**PERSIMMON HOMES
NORTH LITTLEHAMPTON PHASE 1
TODDINGTON LANE S278 WORKS**

AMENDED IDR ARRANGEMENTS

**ROAD SAFETY AUDIT RESPONSE
REPORT TO STAGE 1 RSA ADDENDUM**

Project Code:	PHLITTLE.2/IDR-DR
Prepared by:	AB
Approved by:	SW
Issue Date:	3 MAY 2016
Status:	1st ISSUE

PROPOSED S278 HIGHWAY WORKS
AMENDED IDR GENERAL ARRANGEMENT DRAWING

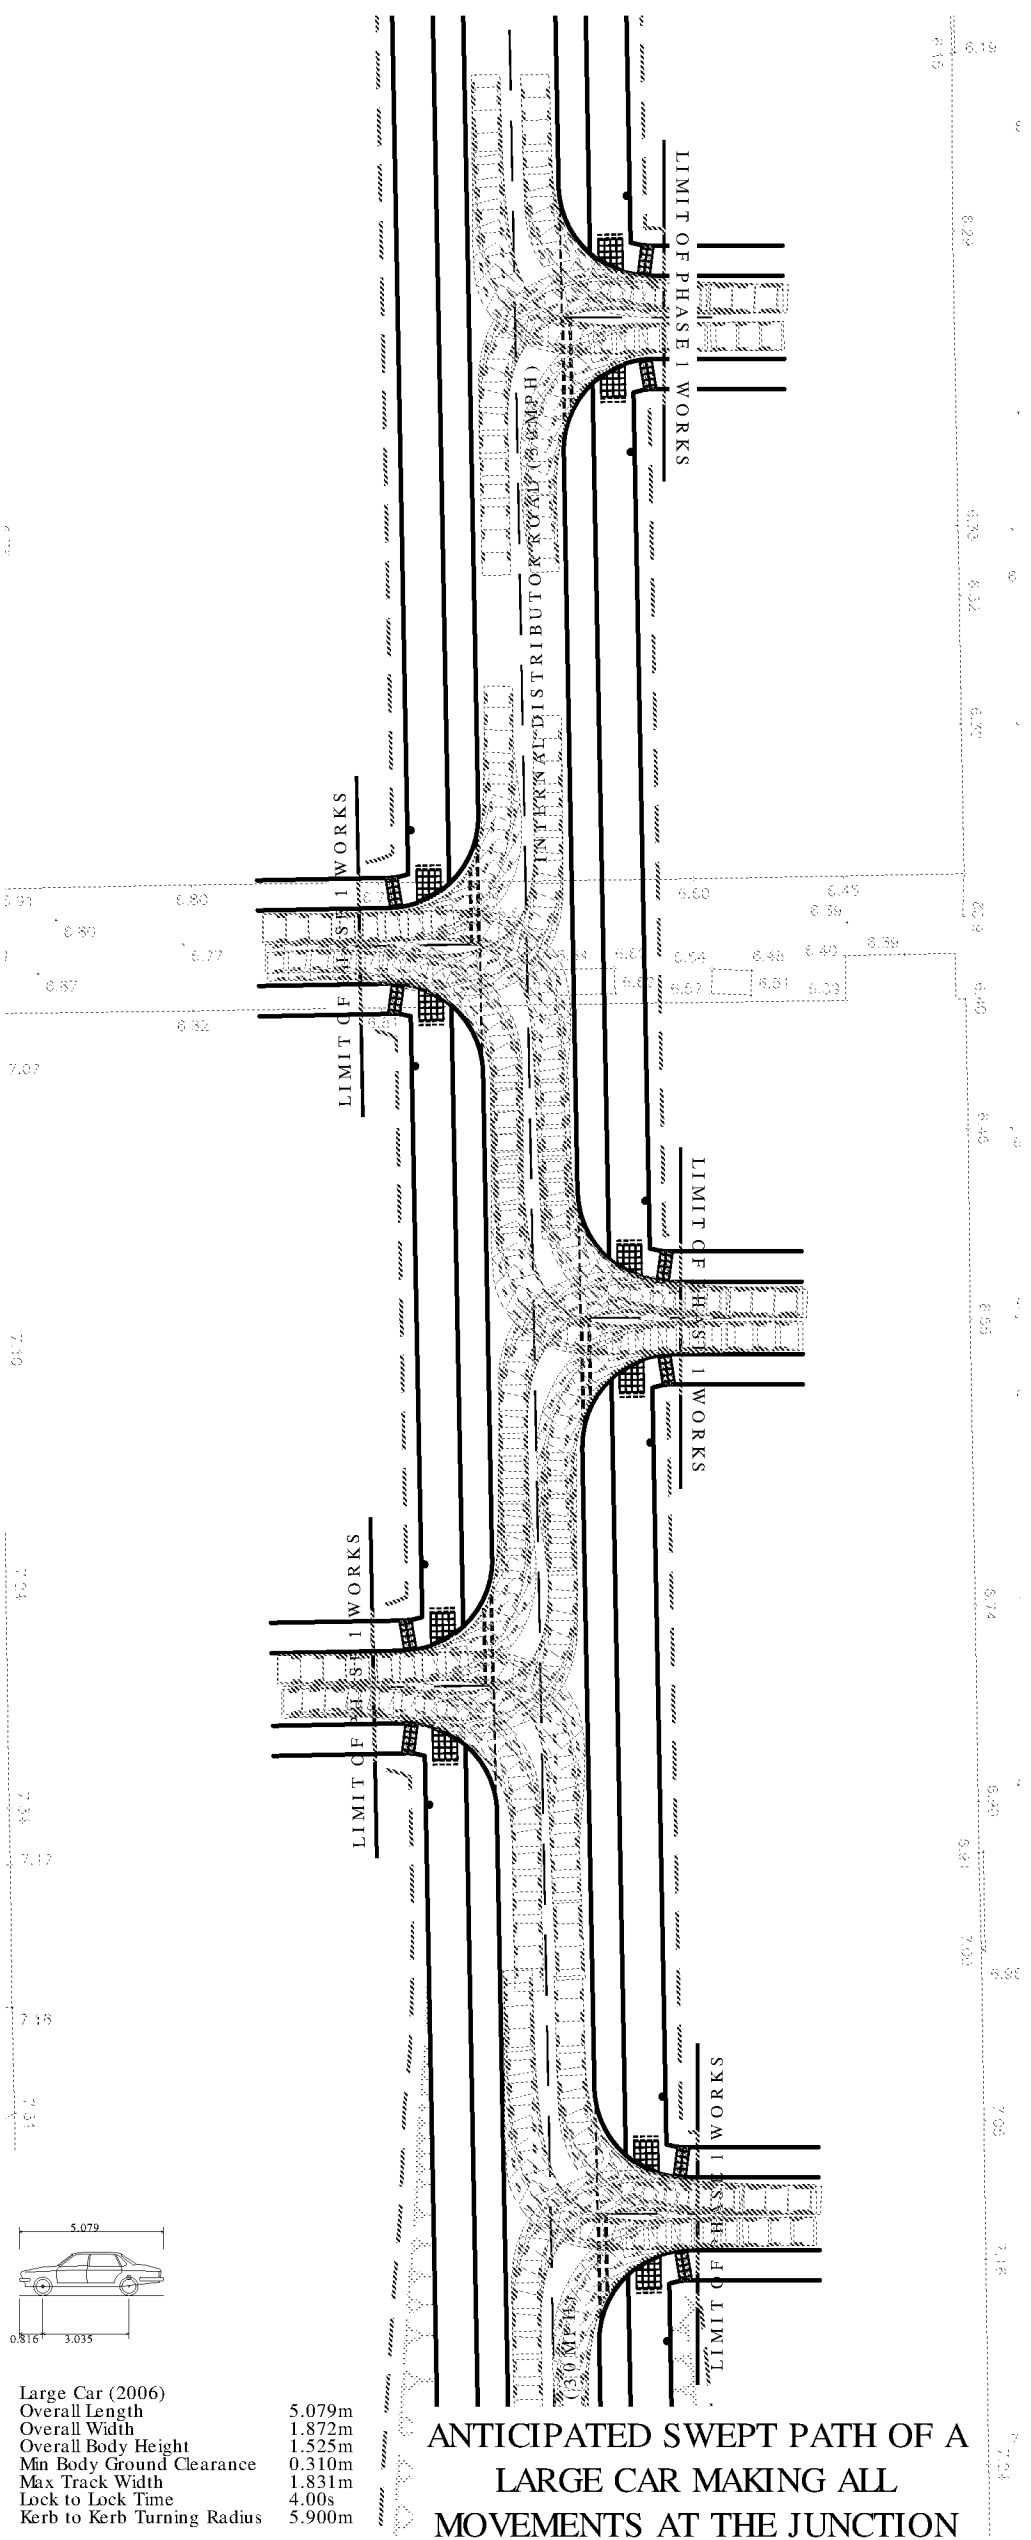
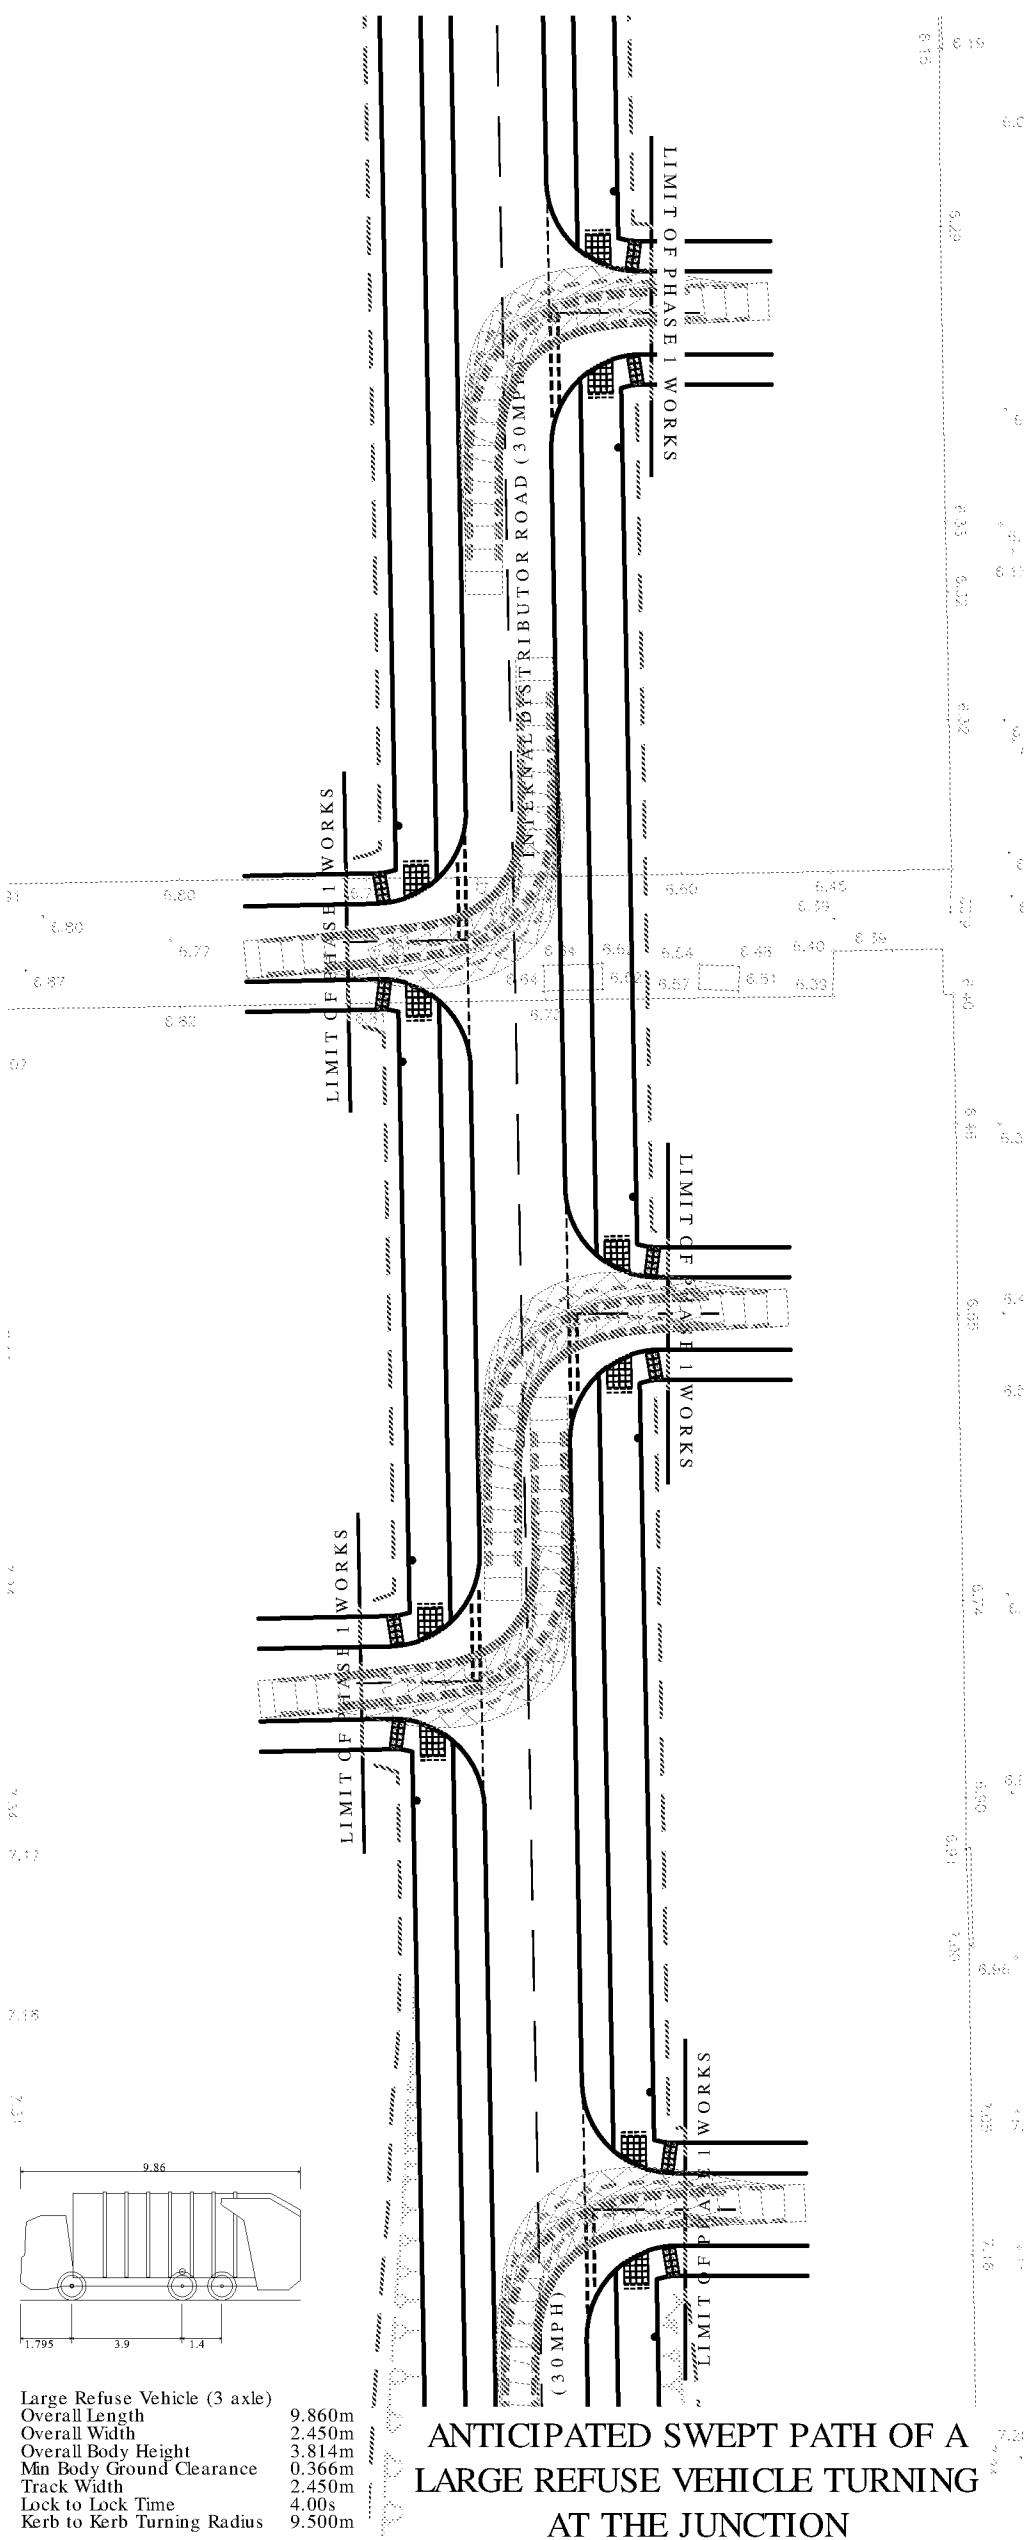
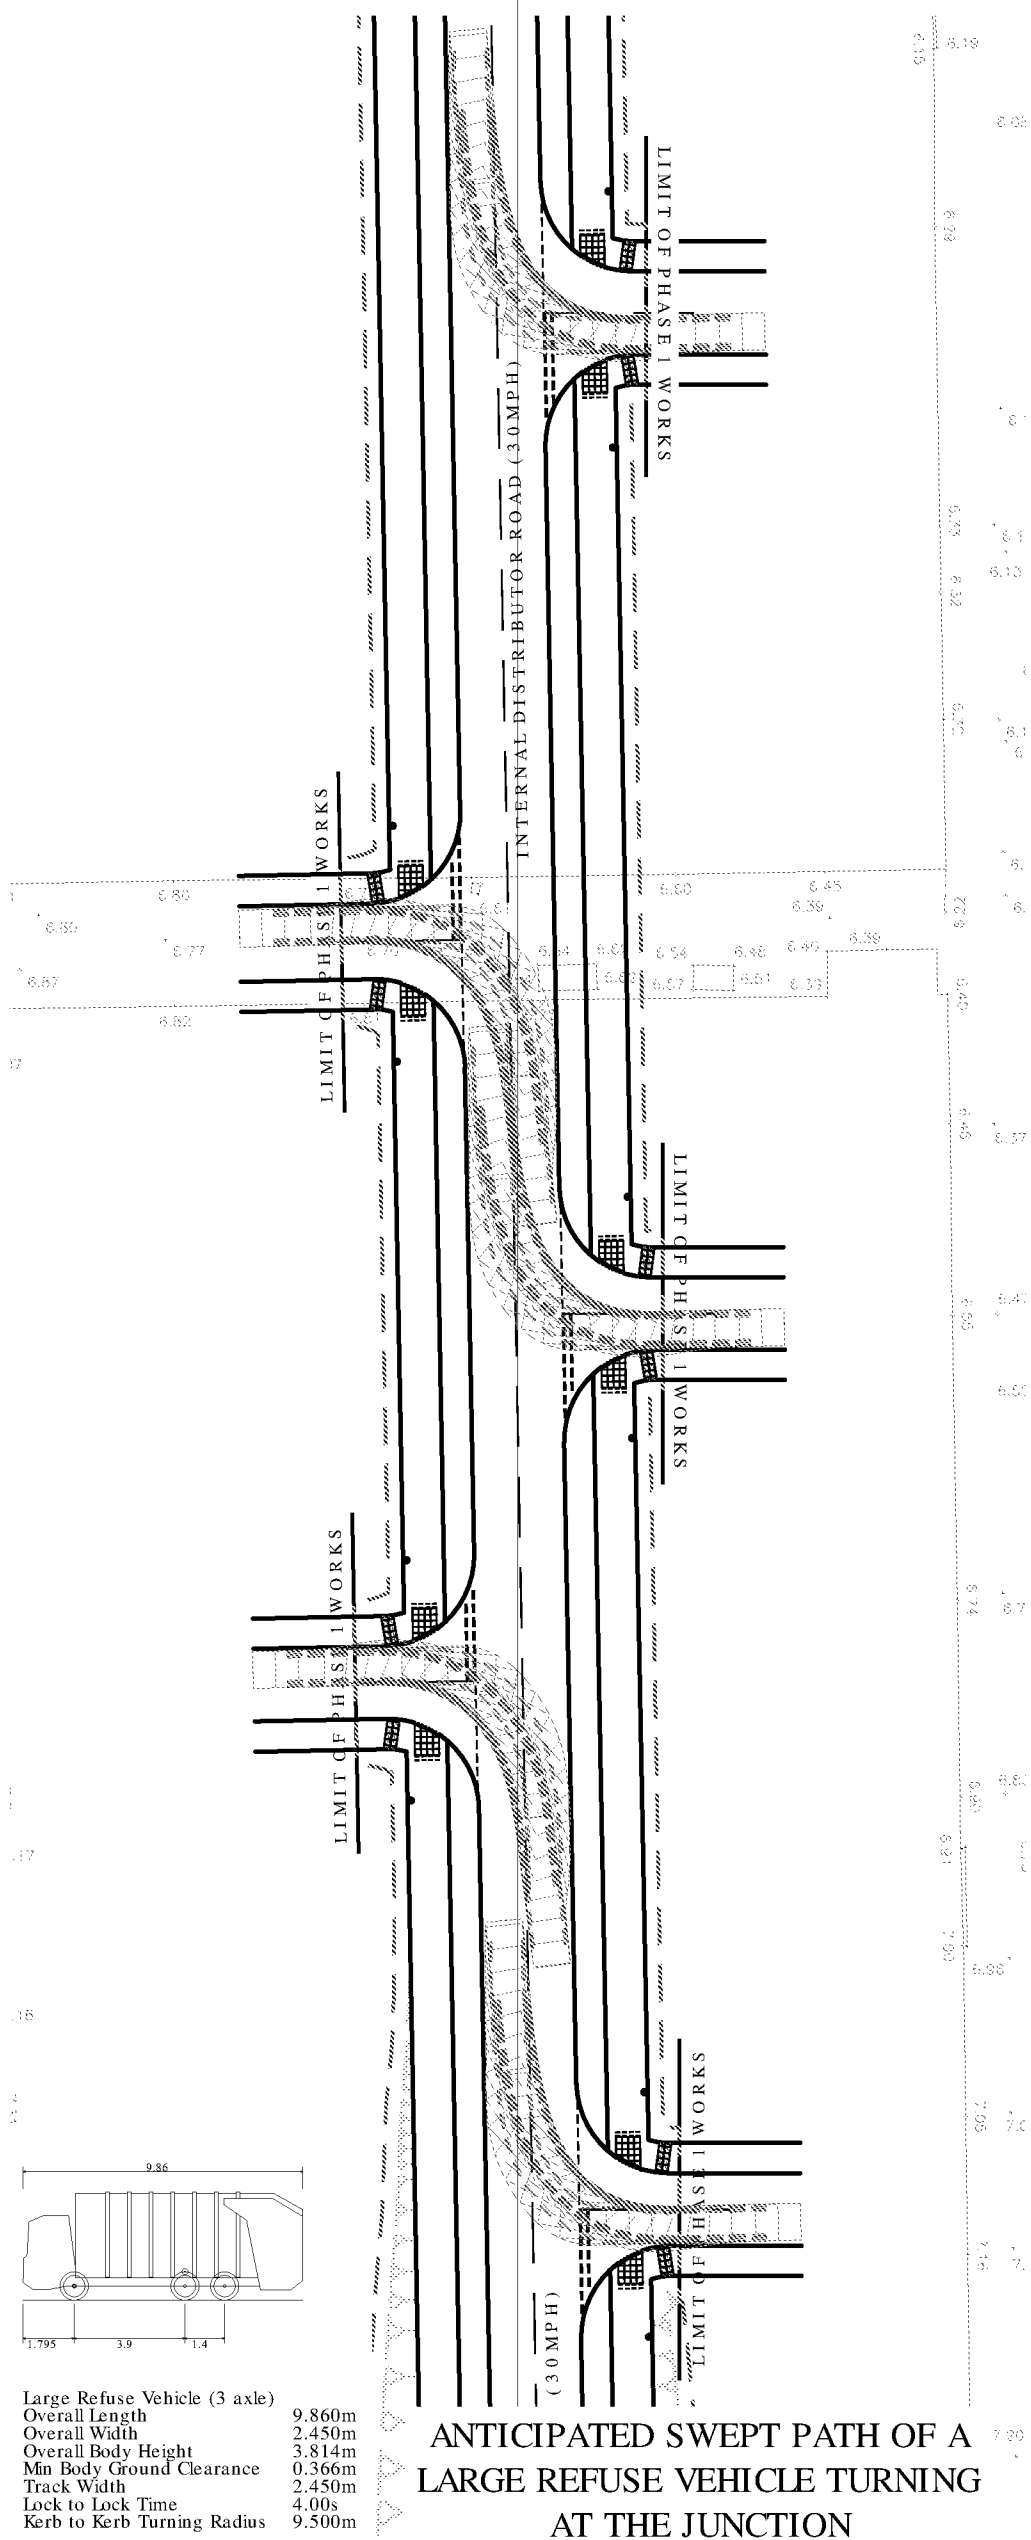
The drawing shows a 20m kerb radius on the west side of the junction. This could encourage relatively high speeds by left-turning vehicles, particularly cars and light vans, and it increases the width of carriageway to be traversed by pedestrians crossing the junction; both of these factors increase the danger to pedestrians from turning vehicles. Whilst it appears from the traffic flow information supplied in the Audit Brief that a significant number of HGVs will use this junction, it is clear from the swept path plots that the radius could be reduced without causing them difficulty.

- i. Reduce the kerb radius as far as possible consistent with providing adequate turning space for the largest vehicles regularly using the junction.
- ii. Inset the pedestrian crossing point slightly further into the junction (c.1.5m) to reduce the crossing width for pedestrians, particularly those with a disability, and increase their visibility to/from southbound vehicles approaching on the IDR.

A considerable number of trees is shown within the verges on both sides of the IDR, some of which are within designated junction visibility splays. Whilst we note that the trees are intended to be of relatively small girth and have clear stems, they will inevitably have some impact on sightlines; this effect will be greater the closer they are to the junction and will increase with time as the trees grow. This will increase the risks of vehicles emerging from the side roads being struck by passing traffic, and of cyclists approaching a junction along the shared path being concealed from drivers intending to turn into the side road.

Do not plant trees within the visibility splays.

Whilst the shared path provision should increase cyclists' safety by removing them from the carriageway, this benefit is likely to be largely nullified by the frequent interruption of the route by side road junctions where cyclists are not given priority; in these circumstances, although children may cycle along the path, confident cyclists are more likely to remain in the carriageway to avoid the possible need to keep stopping. In addition, the side road junctions are drawn with 8m kerb radii, which will not significantly reduce turning vehicle speeds to maximise the safety of pedestrians and cyclists. In accordance with Manual for Streets advice it would be better in most cases to keep kerb radii to a minimum and accept that larger vehicles will occasionally need to cross into the opposing lane of the IDR to make the turn. The Auditors have not been provided with details of the individual development areas to be served off each side road, but in some cases (i.e. if only a small number of dwellings is proposed) it may be appropriate to provide access in the form of a dropped kerb and footway crossing rather than a kerbed bellmouth. Alternatively it may be appropriate to provide entry treatments such as entry ramps, raised tables and/or set back Give Way markings.

Reconfigure the side road junction treatment (providing cycle priority if possible) to improve continuity of the cycle route.

- (i) Accepted. Kerb radius reduced, as recommended, by the provision of a compound kerb.
- (ii) Accepted. Crossing point inset 1.5m further as recommended.

Accepted. 16 no. trees within visibility splays removed as recommended.

Accepted. Junction radii were initially indicated to be 6m but WSCC requested via comments dated 11 Feb 2015 that we consider increasing them. Subsequently, the radii were increased to 8m. However, the radii have been reduced back to a minimum of 6m as recommended. As set out in the Auditor's summary, this will require larger vehicles such as the occasional refuse vehicle to cross into the opposing lane to make the turn, although this would have happened with the 8m radius as well.

D	Trees amended & Toddington Lane junction and Development access junctions amended following Stage 1 Road Safety Audit Addendum Report. (OIN)	AB	03/05/2016
C	Cycle intervisibility spays shown. (OIN)	AB	29/04/2016
B	Indicative Residential layout and pedestrian intervisibility spays added. (OIN)	AB	27/04/2016
A	Trees and tree types added. (OIN)	AB	30/03/2016
